UPMC Mercy Hospital  
Institutional Master Plan Revision | 9 April 2018

**Mercy Hospital**  
**Project Area Master Plan**  
GBBN# 12849 UPMC# 110326

Project Area Master Plan  
**UPMC Mercy**  
June 14, 2012  
**Amendment: April 9, 2018**

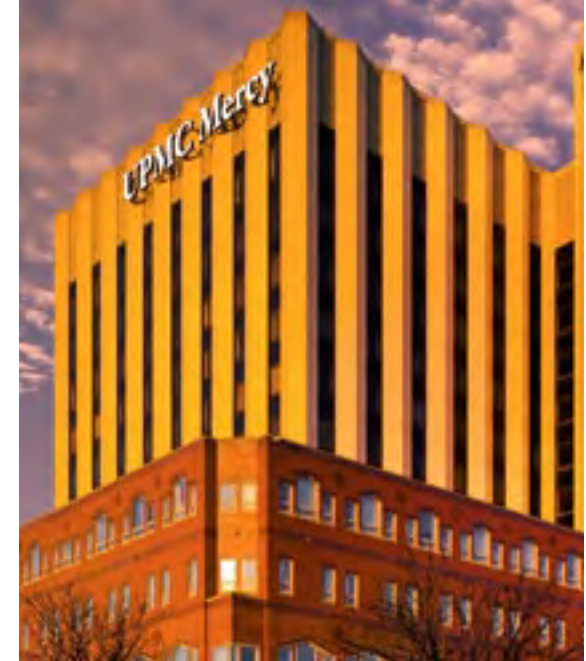
**5b. Boiler Building** adjacent to St. Ann's will be torn down after new boilers are located in the new ~~central Power Plant~~. **\*NRG district energy plant.**

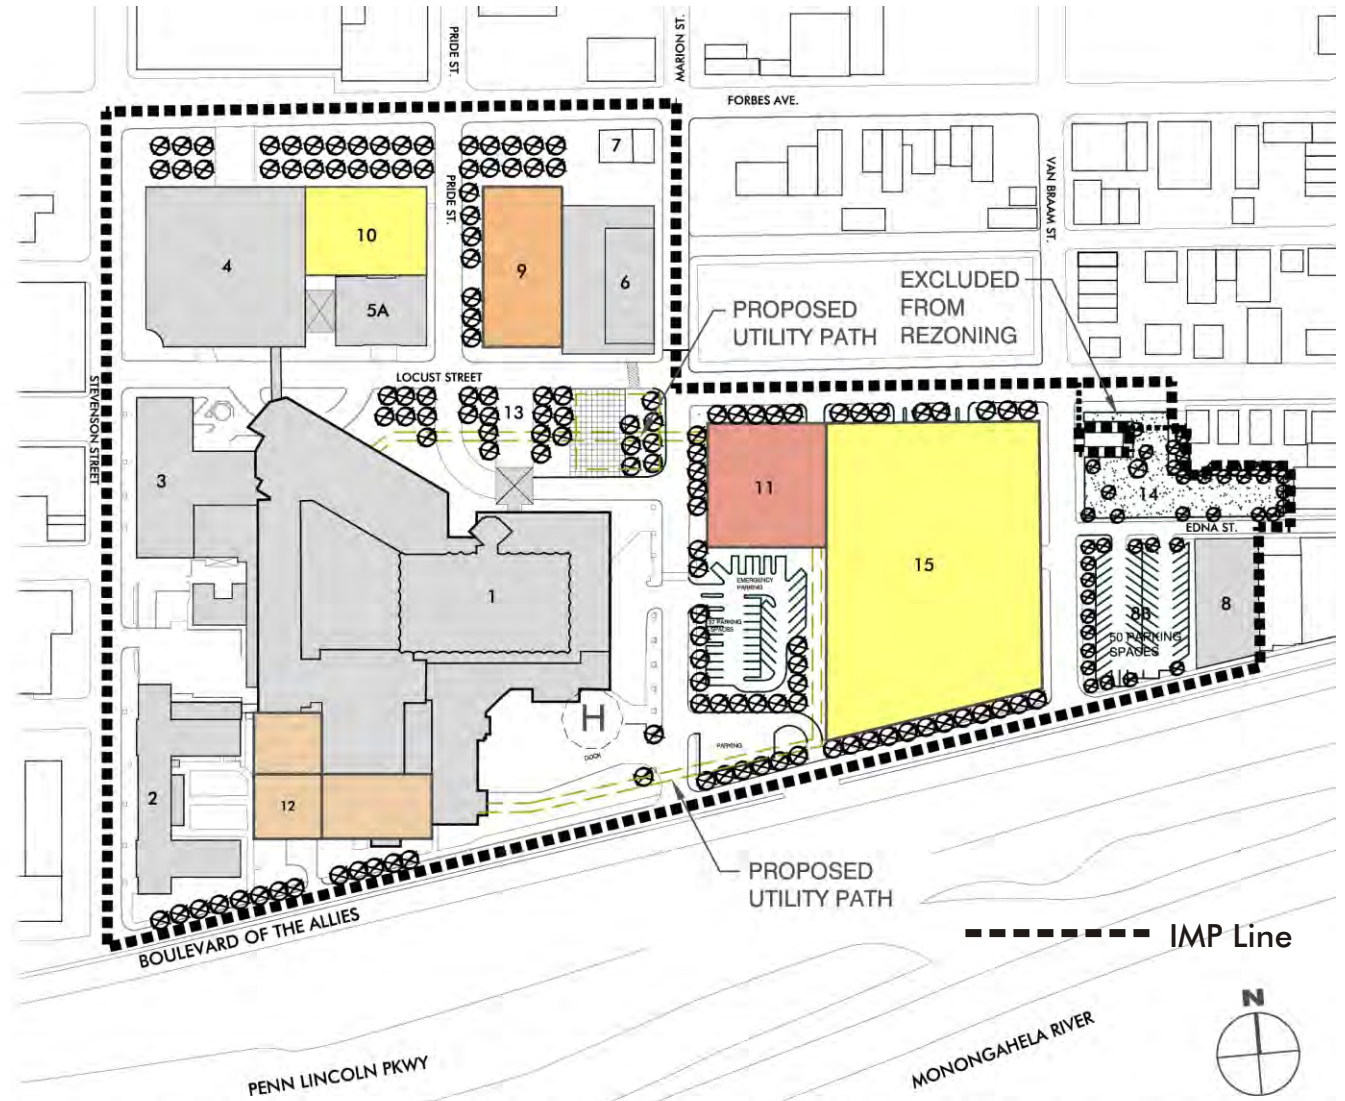
~~1. Position a new central power plant with a footprint of 20,000 GSF and overall SF of 60,000 GSF on 3 levels including cooling towers, offices and maintenance shops. Height shall not exceed 65ft for the three storeys (see pg.13,#11). Screening of the cooling towers will be provided on the roof, starting at 65ft. Initial phase will house chillers now located in a number of locations. The plant will be completed over the next few years to eventually produce a completed unified energy center. Direct burial utility lines will be placed along the Locust St. R.O.W. from the central power plant to the northwest and southern sections of the main hospital building.~~

7. Consider razing ~~St. Ann Center and~~ Boiler House to expand existing parking. Provide additional parking for 360 to 540 cars in a structured parking garage to be located adjacent to the Locust St. structured garage if St. Ann Center is to remain. The new garage shall provide additional access to Pride St.. The new garage will be constructed on the former site of the Boiler Building. Additional directional signage within the Locust St. garage will increase usage of the Forbes Avenue entrance and exit. Additional exits for Pride St. are proposed.

11. The UPMC campus is currently zoned EMI with surface parking lots located in NDI and LNC zones. The UPMC Mercy campus in its entirety should be rezoned EMI. see pg. 4, except the corner parcel on Van Braam St. and Locust St. **COMPLETE**

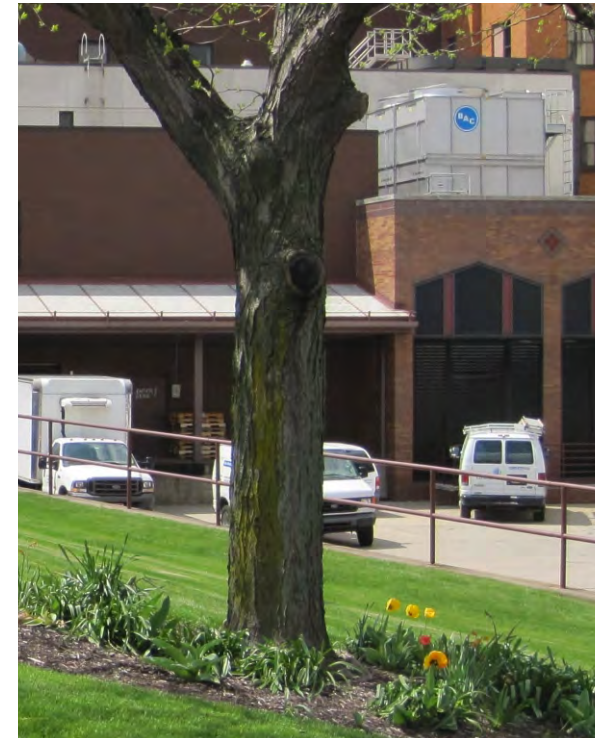
~~The maximum height of any building on the campus will be the existing 12 story patient tower of 180 feet.~~

**\*The tallest point of new construction shall be closest to the existing tower and step down towards the neighborhood. The current 25 year mass is conceptual in nature and may change in next iteration.**
